P802.3cs (Super-PON) Spectral Excursion

Add to 200.2.9.20:

Add Annex 200C

Figure 200C-1 – Experimental setup for testing for transient wavelength drift

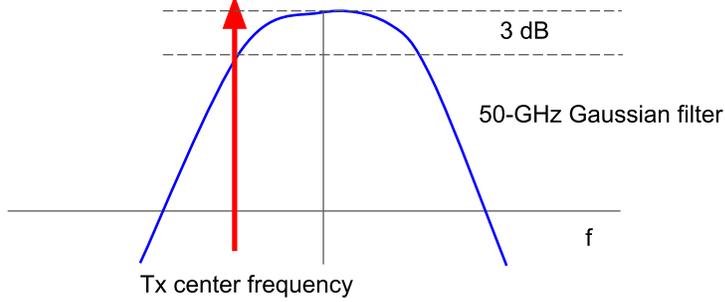
- a) Position between the transmitter and a linear PIN photodiode a 50 GHz tunable Gaussian optical filter with the center wavelength detuned from the ONU’s continuous-mode wavelength by 25 GHz , as shown in Figure 200C-1. This results in 3 dB less power into the photodiode relative to ideal alignment between the filter’s center frequency to the transmitter;

Figure 200C-2 - A potential power envelope output after filtering

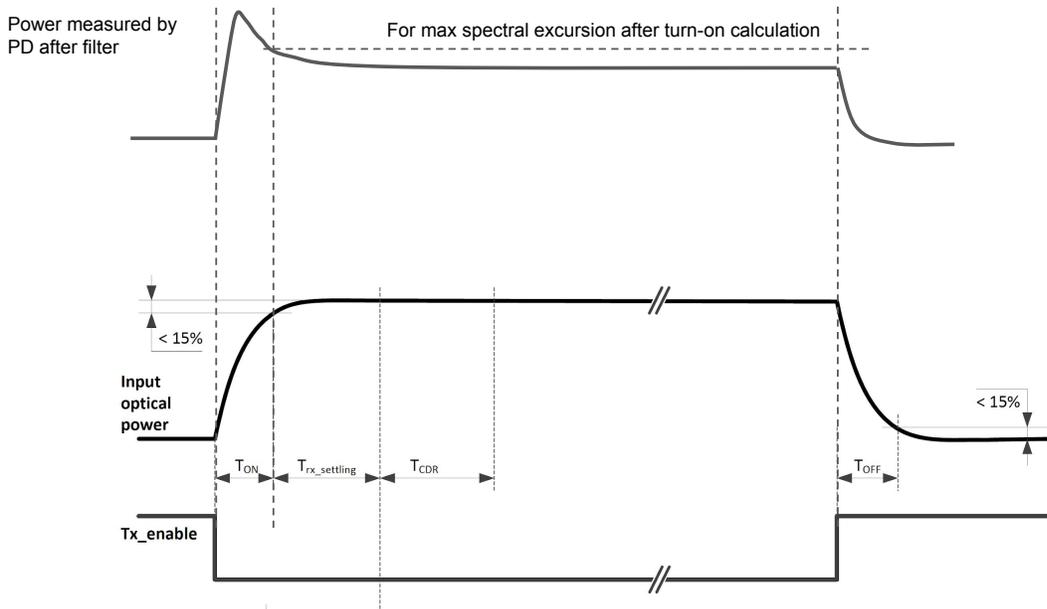
- b) Use a burst-mode signal to drive the ONU transmitter with bursts of >100 us;
- c) Capture the power envelope of the time domain waveform output from the photodiode. The offset optical filter translates frequency shifts into a power envelop change. An example measurement is show in Figure 200C-2;

- d) Measure the difference in the power envelop between laser on time after the burst start and after the laser has reached steady state;
- e) Convert the change in the measured power envelop into a transient frequency shift by using the Gaussian relationship of the filter.
